IEUA New Headquarters Bldgs

SUMMARY OF PRELIMINARY REVIEW COMMENTS:

2500 Highway 41 Suite 125 San Jose, CA 95128 408.260.0000 408.260.0003		INLAND EMPIRE UTILITIES AGENCY A Member of the SOUTHERN CALIFORNIA GAS COMPANY 1700 North Main Street San Jose, CA 95131 (408) 281-1700		IEUA HEADQUARTERS PHASE 1 - PROJECT # EN 02038 TREE PLANTING PLAN L-801	
REVISIONS NO. DATE 1 3/25/03 2 6/7/03 3		DESIGNED BY: WS DRAWN BY: BG CHECKED BY: TW/AC DATE: 12/13/02 BY: 12/13/02 DATE: 12/13/02		REVIEWED BY: _____ PROJECT MANAGER: P. BIA DATE: _____	
FIRST PLAN CHECK: REVISION SECOND PLAN CHECK: REVISION BOUNDARY REVISION		SCALE AS SHOWN 1" = 40'-0"		NOTES: - SEE SHEET L-101 FOR KEY MAP - SEE SHEET L-800 FOR SHRUB/TREE LEGENDS & DRY HYDROSEED MIX (NON-IRRIGATED)

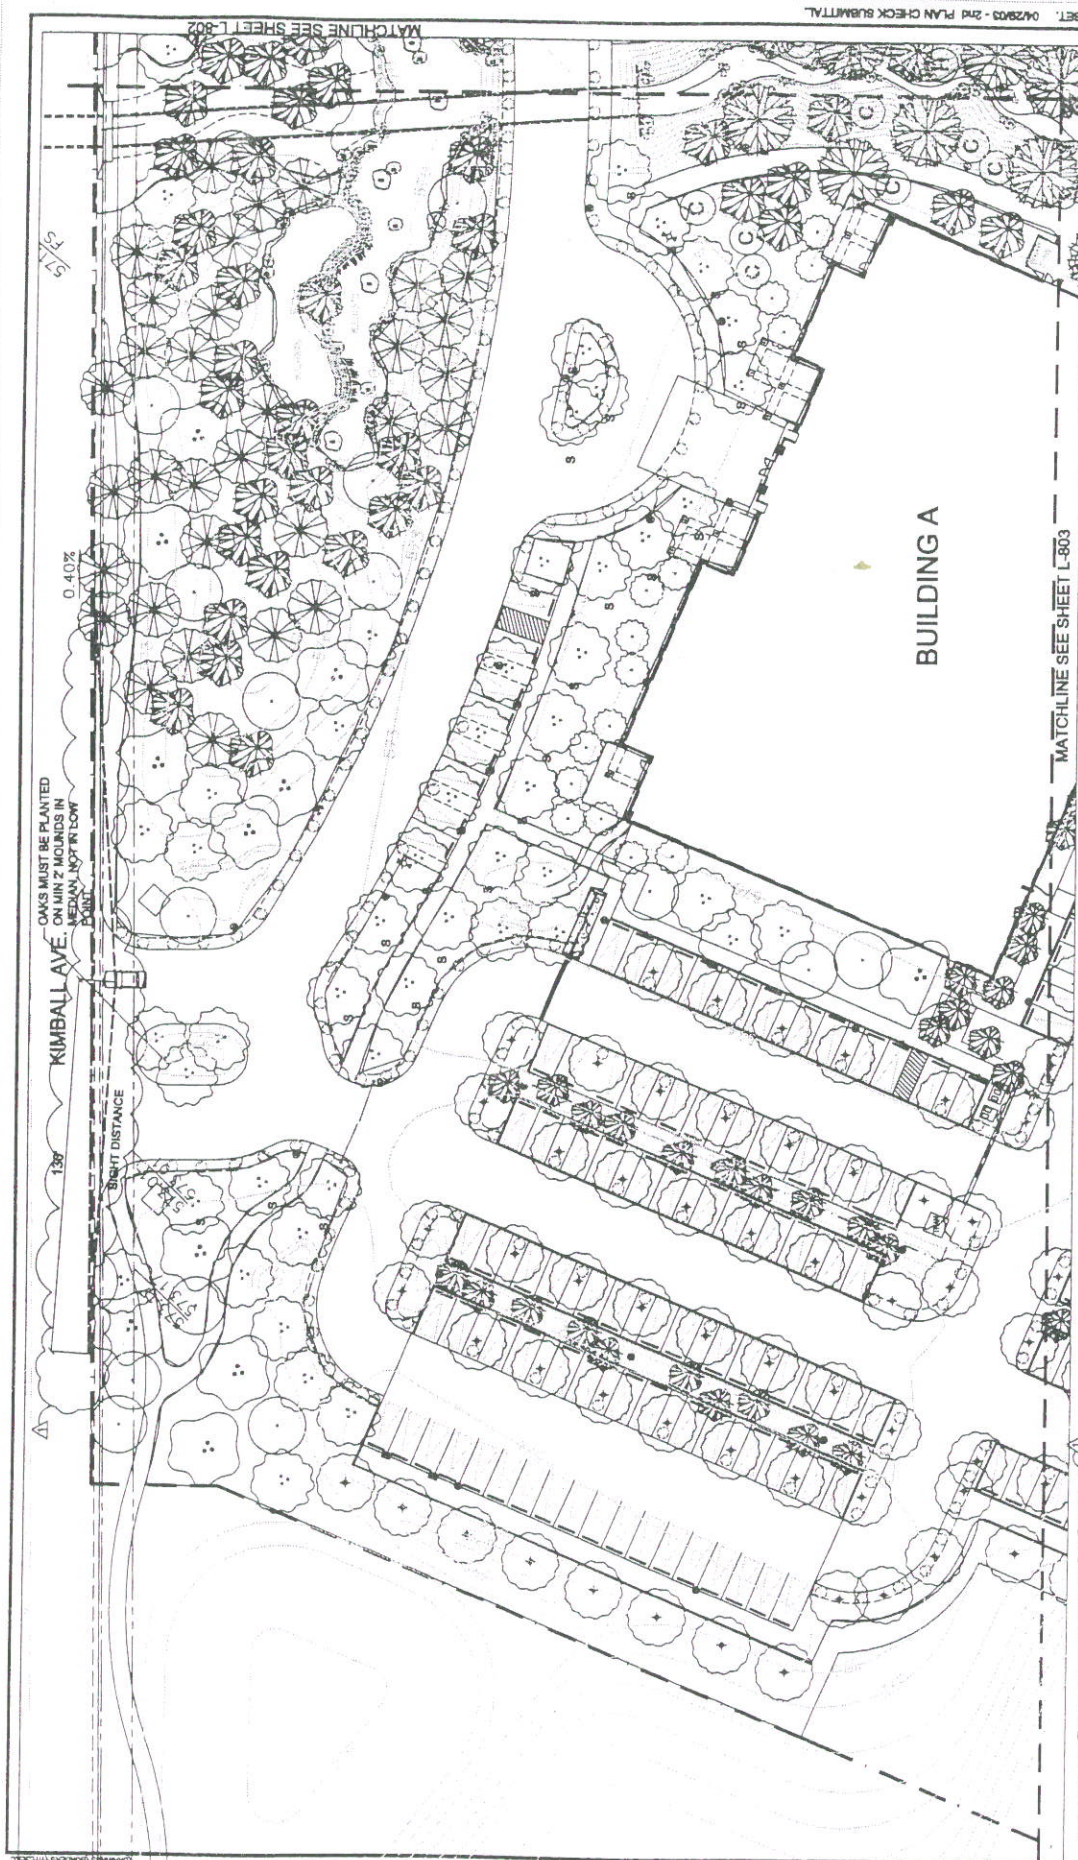
- 1) The site boundary presented is inconsistent with other site boundaries.
- 2) The restored site area drawing shows sidewalks within the area keyed as restored. Restored areas shall not include sidewalks, paved areas, turf play fields or conventional lawns.
- 3) It is unclear if the 32,948 s.f. expansion area is included in the calculation of restored area.

- 1) The site boundary presented in all credits is consistent. Square footage numbers have been verified and are consistent across all credits. The site boundary line, although consistent, was drawn differently, making it appear inconsistent. The graphical differences have been made consistent to ensure that all drawings are consistent in appearance.

- 2) The walkways depicted within the restored area are decomposed granite paths and not paved sidewalks. These paths provide access for visitors and maintenance staff while maintaining a natural environment within the restored area. These pathways will be used to link the headquarters site with a larger restored area located to the south of the site. The attached narrative from IEUA describes the restoration process and the plans for extension of this natural habitat.

- 3) The 32,948 s.f. expansion area is not included within the overall calculation for restored areas. Calculations on the revised exhibits have been tabulated to clearly demonstrate this.
